Premature Termination of Fax/Data Links with 9323/9360 Transceiver

9323/9360/9780/9390 Software Compatibility Summary

9323/9360/9390/9680/9780 lock up

VCO1 Unlock in 9323 & 9360 series transceivers

Figure 1: Location of components

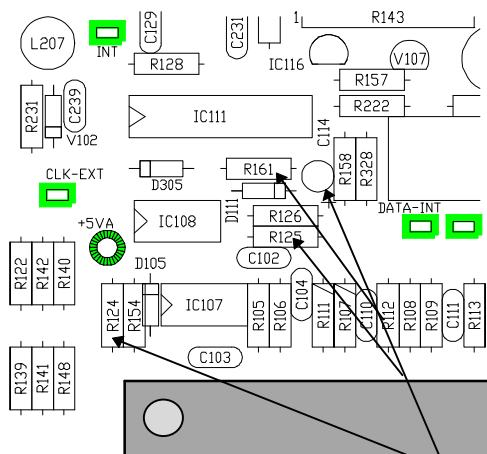
- ☐ Remove the transceiver (including the control head where applicable) from the installation.
- ☐ Remove the two screws securing the bottom cover and remove the cover.
- ☐ Locate the Microprocessor and Audio Assembly PCB (Printed Circuit Board), 08-04966-001.
- ☐ Disconnect all the ribbon cables from the PCB taking careful note of the orientation of the connectors on P103 and P302.
- ☐ Remove the eight screws securing the PCB.
- ☐ Withdraw the PCB from the chassis.
- ☐ Locate and remove R124, R125, R126, and C114. Refer to Figures 1 and 2.

R124, R125, R126, R161, D111, C114

- ☐ Remove R161 and D111 if fitted. Refer to Figures 1 and 2.
- ☐ Locate IC107 (LM358). Refer to Figure 3.

Figure 3: Location of IC and 47 kΩ resistor

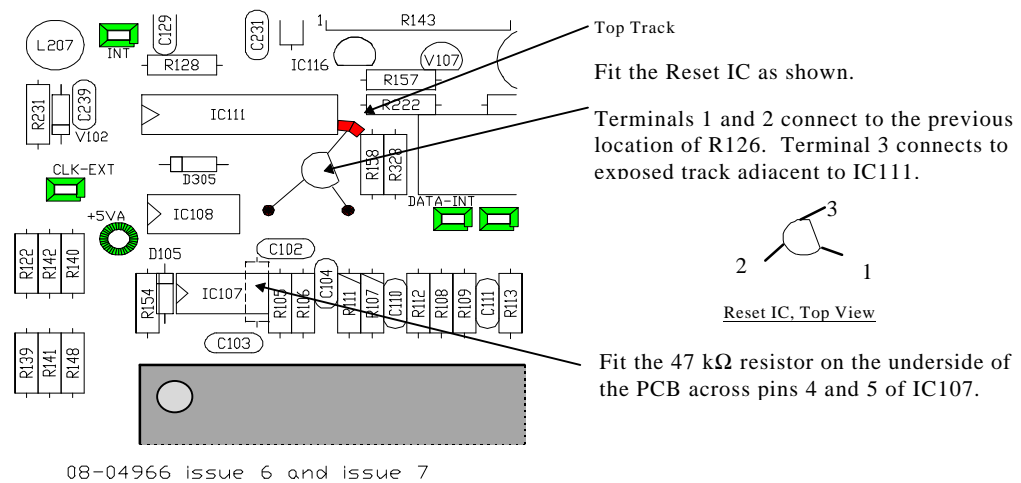
- ☐ Fit and solder the 47 kΩ resistor across pins 4 and 5 of IC107. This is best done on the underside. Refer to Figure 3.
- ☐ Locate the track on the component side of the PCB adjacent to IC111. Refer to Figure 3.
- ☐ Using the scalpel or blade, carefully scrape the green masking from the track so that approximately 2 mm of bare copper is exposed.
- ☐ Tin the exposed copper.
- ☐ Fit the Reset IC as shown in Figure 3.
- ☐ Fit and secure the PCB into the chassis with the eight screws.
- ☐ Replace all ribbon cables onto their corresponding connectors paying particular attention to the orientation of P103 and P302.

**Figure 4: Location of components****Figure 5: Location of components**

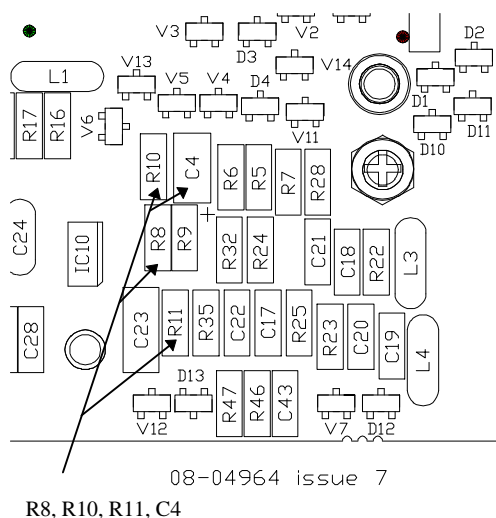
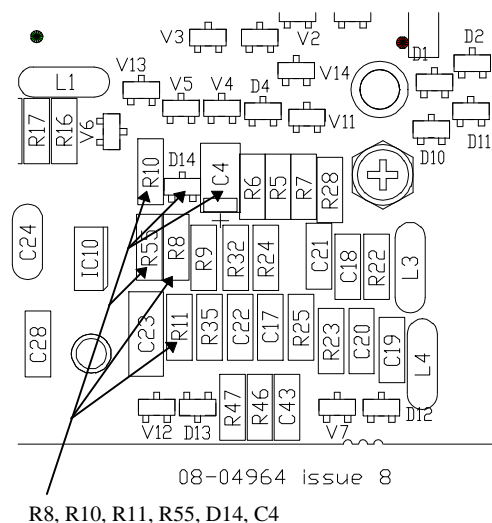
- ☐ Locate R8, R10, R11, and C4. Refer to Figures 4 and 5.

- ☐ Using a pair of tweezers (or small nose pliers) and soldering iron, or a SMD desoldering tool, remove R8, R10, R11, and C4 from the PCB.
- ☐ Remove R55 and D14 if fitted. Refer to Figures 4 and 5.
- ☐ Fit and solder the 47 k Ω resistor as shown in Figure 6 or 7.

Figure 6: Location of IC and 47 k Ω resistor

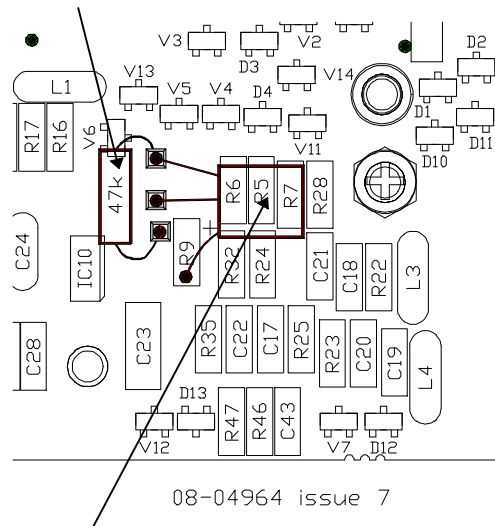
Fit 47 k Ω resistor between R8 and R10 pads as shown

Fit Reset IC to, R10 pads and to R9—**Flat side UP**

- ☐ Fit and solder the Reset IC as shown in Figure 6 or 7.

Figure 7: Location of IC and 47 k Ω resistor

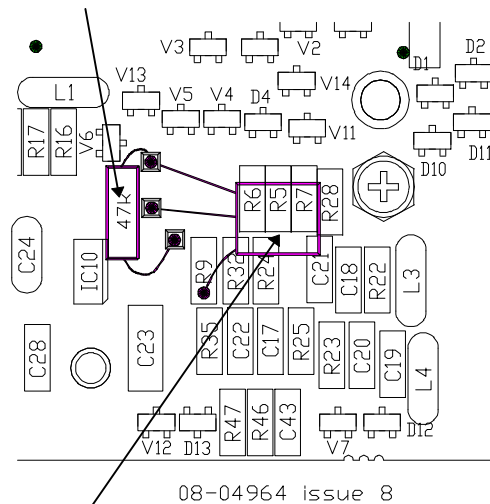
Fit 47 k Ω resistor between R8 and R10 pads as shown

Fit Reset IC to, R10 pads and to R9—**Flat side UP**

Figure 2 Diagram of modification

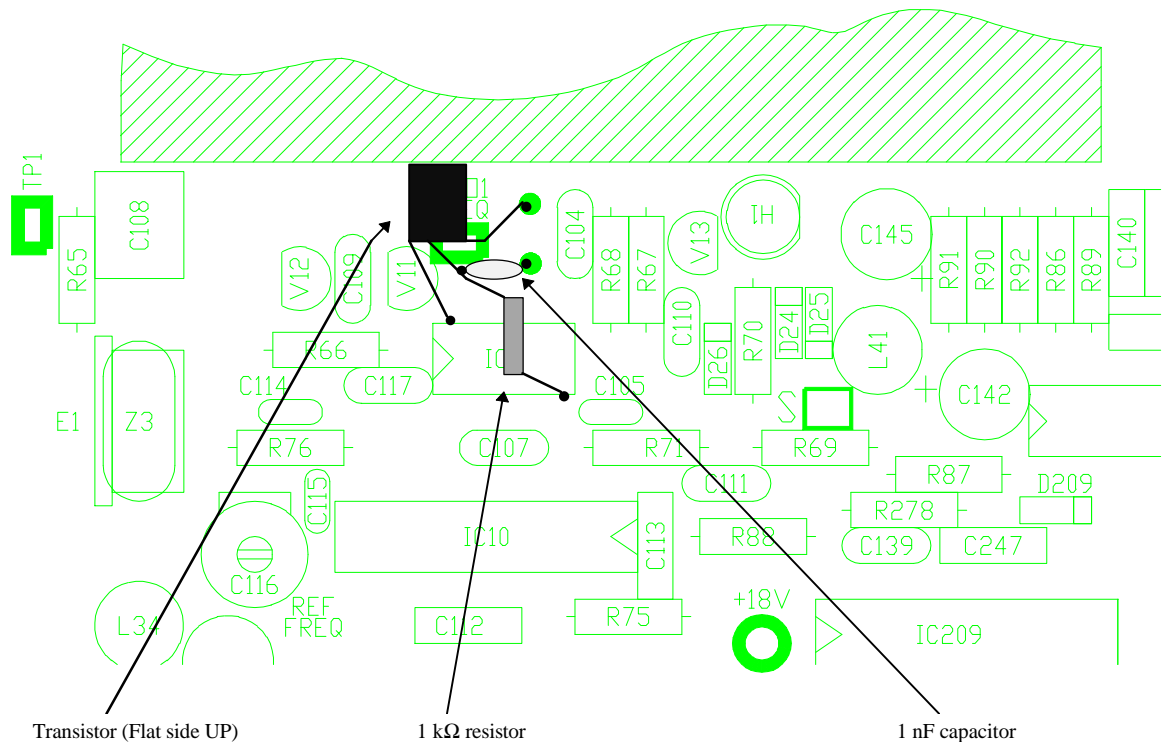
- ☐ Trim and solder one lead of the 1 k Ω resistor to IC9 pin 4. Refer to Figure 2.

- ☐ Fit one lead of the capacitor into the bottom hole for C103. Trim and solder.
- ☐ Solder the remaining leads of the capacitor and the resistor together.
- ☐ With the transistor flat side up, solder the centre lead to the leads of the capacitor and resistor. Trim any excess lead.
- ☐ Trim and solder the Collector of the transistor to IC9 pin 8.
- ☐ Fit the Base of the transistor into the upper most hole for C103. Trim and solder.
- ☐ Ensure there is no possibility of a short circuit occurring particularly to the test point labelled VCO1 FREQ.
- ☐ Secure the transistor with some silicon sealant if necessary.
- ☐ Secure the PCB into the chassis with the seven screws.
- ☐ Replace all connectors.
- ☐ Refit and secure the top cover.
- ☐ Return the transceiver to the installation.

Figure 1: Power amplifier PCB for the 93xx series/9780 and LP transceivers

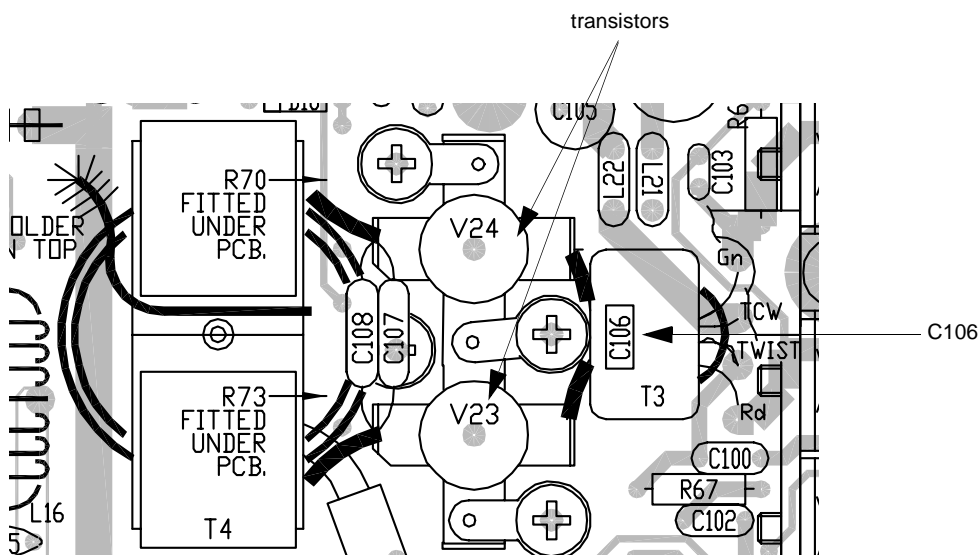
- ☐ Remove the two faulty transistors from the PA PCB (see Figure 1).

- ☐ Replace C106 with a capacitor that has a value of 470 pf.

Later model 93xx series/9780 PAs (Codan part number 08-04963-xxx) may already have the 470 pf capacitor in place. If you are unsure of the value of C106, it is recommended you replace it with a 470 pf capacitor as a precaution.

- ☐ Replace the transistors with MS1253-CDN.
- ☐ Continue from [page 3, Adjusting the driver bias for power amplifiers in 93xx series/9780 and LP transceivers.](#)

Figure 2: Power amplifier PCB for the 85xx series/9313/9480 transceivers

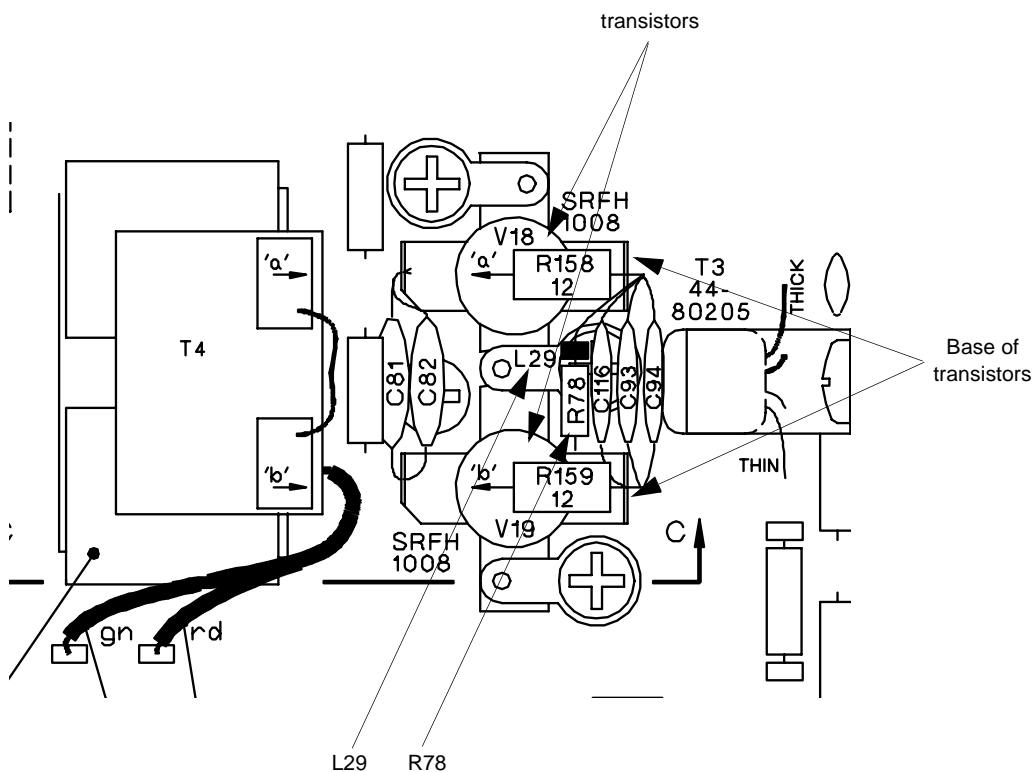
- ☐ Check if there is a resistor/choke (R78/L29) across the base of both transistors on the PA PCB (Codan part number 08-03743-xxx) (see Figure 2).

If R78/L29 is not present, it must be fitted.

- ☐ Replace the transistors with MS1253-CDN (see Figure 2).
- ☐ Continue from [page 5, Adjusting the output bias in all transceivers](#).

Figure 3: Replacing the fuse

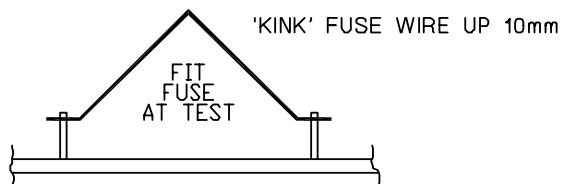
- ❑ If the **PA O/P** fuse is broken, do the following:
- Replace the **PA O/P** fuse with two strands (2×0.2 mm TCW) taken from a piece of 7×0.2 mm cable.
 - Solder the wire ends to the stakes as shown in [Figure 3](#).
 - Kink the wire up 10 mm to form an inverted V as shown in [Figure 3](#).

Figure 1: Hardware modification to the Microprocessor and Audio PCB (07-01536-11)

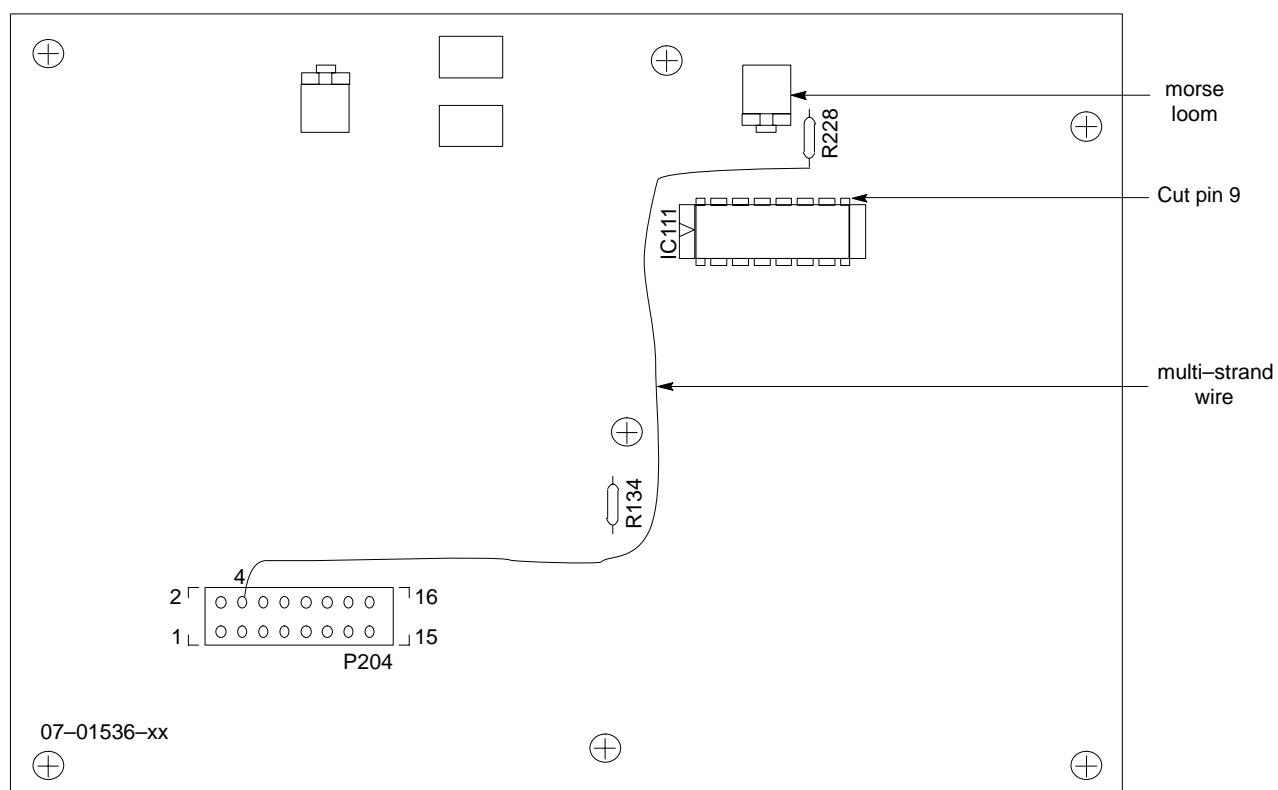
- ☐ Switch the power off.
- ☐ From the component side of the Microprocessor and Audio PCB (assembly part number 08-04966, PCB part number 07-01536-11), cut pin 9 of IC111 using side cutters (see Figure 1).

- ☐ Route the multi-strand wire (part number 66-02072-005) from R228 to pin 4 of P204 (see Figure 1).

To improve the morse switching speed of the transceiver, upgrade to software version 4.35 and perform the following hardware modification.

Figure 1 Location of R273

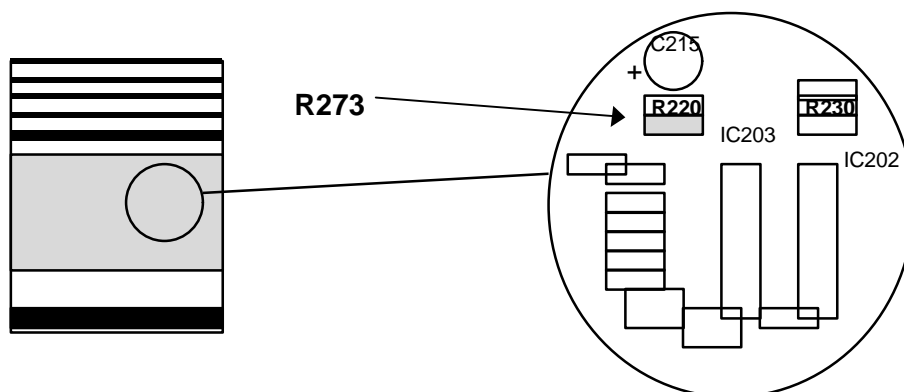
The introduction of Version 3 software redefined the use of the I/O (Input/Output) ports of IC209 on the Receiver/Exciter PCB (P/No 08-04962-001) within the transceiver. This change produced an effective desensitisation of the receiver of some 10dB. To overcome this, the line from Port 3 of IC209 (Pin 7) should be disconnected. This is best achieved by the removal of resistor R273. Once removed you should note an improvement in receiver performance. Transceivers factory fitted with Version 3 or later software already incorporate this modification.

1. Remove the transceiver top cover.
2. Locate the Receiver/Exciter PCB, part number 08-04962-001.
3. With the front panel towards you, locate R273 (100K ohm resistor).

4. Remove R273 from the PCB by carefully cutting both leads with a pair of side cutters.
5. Replace the transceiver top cover.

**Figure 1: Location of IC11**

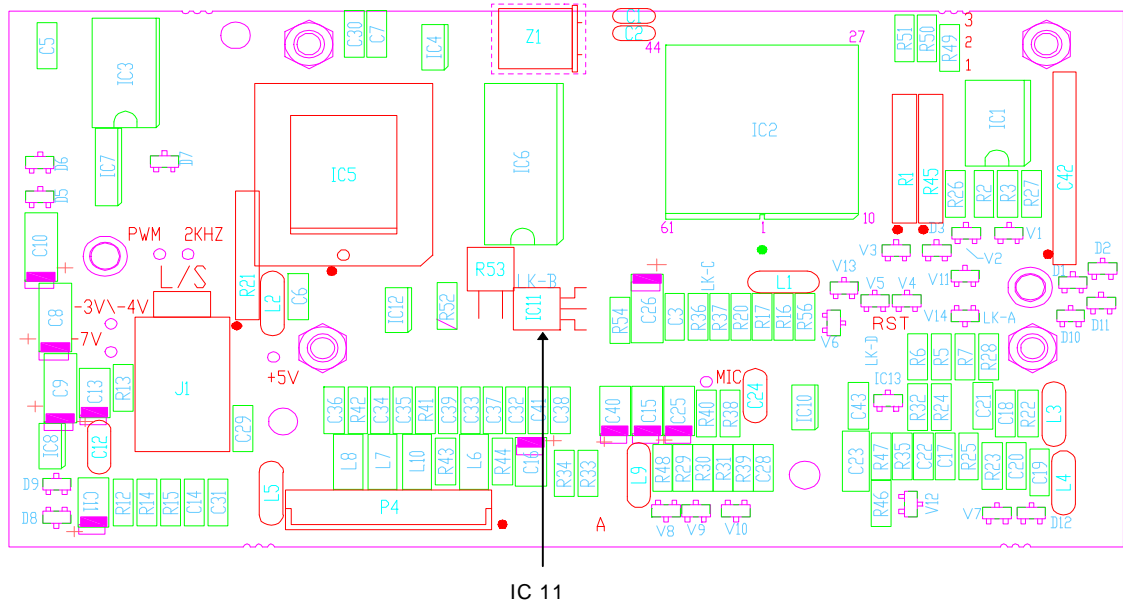
- ☐ Locate IC11. Refer to Figure 1.

- ☐ Carefully lift IC11 up off the board so that the identifying markings on its flat side may be read.
- ☐ Check that the regulator has a manufacturer's marking such as a **trademark** or a **name**.
- ☐ If IC11 does not have a manufacturer's trademark or name it will need replacing. Continue at *Procedure: changing the regulator*. Otherwise, continue at *Reassembly*.

Figure 2: Formation of regulator leads

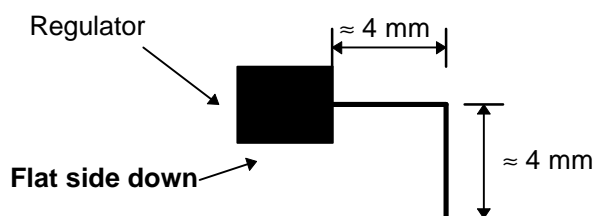
- ☐ Cut each of the three leads of the regulator as close as possible to the body of the regulator.
- ☐ Using the soldering iron and the pliers, heat each joint and remove the leads from the board.
- ☐ Using the desoldering tool or the desoldering wick, clear the solder from the three holes.
- ☐ Form and trim the leads of the replacement regulator. Refer to Figure 2.

- ☐ Insert the regulator into the three holes. *Flat side down*. Refer to Figure 1.
- ☐ Solder the three leads into the display board.

Figure 1: Position of R73 and R74 (Bottom Left Hand Corner of 08-04962)

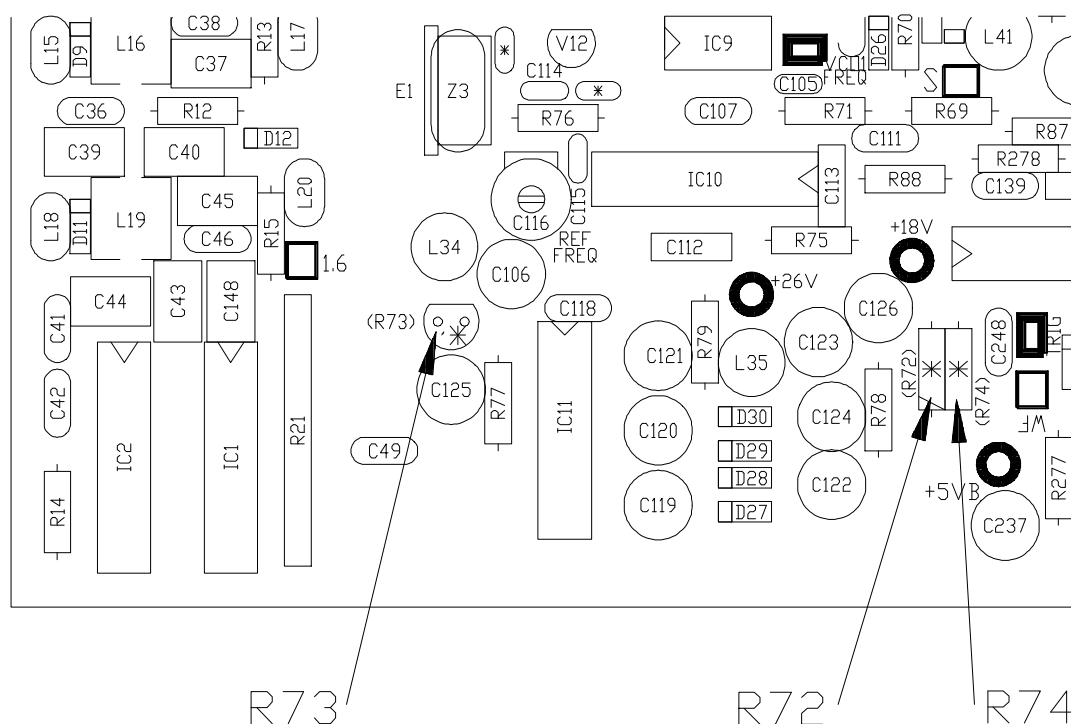
The overlay diagram 08-04962-001 shows the position of R72 and R74 transposed. The correct position of R74 is adjacent to C248 and test point +5VB.

1. Disconnect power from the transceiver and remove from the installation.
2. Remove the top cover.
3. Referring to the diagram, locate the position of R73 and R74. (Neither of these resistors are fitted).

4. Remove the Receiver Exciter assembly from the chassis.
5. Using tinned Copper Wire (TCW), fit and solder a link into the holes marked R73. Trim excess lead length.
6. Fit and solder the $1K\Omega$ resistor into the holes marked R74. Trim excess lead length.
7. Fit and secure the Receiver Exciter assembly into chassis.
8. Refit plugs ensuring correct placement and orientation.
9. Fit top cover
10. Reinstall
11. Connect power.
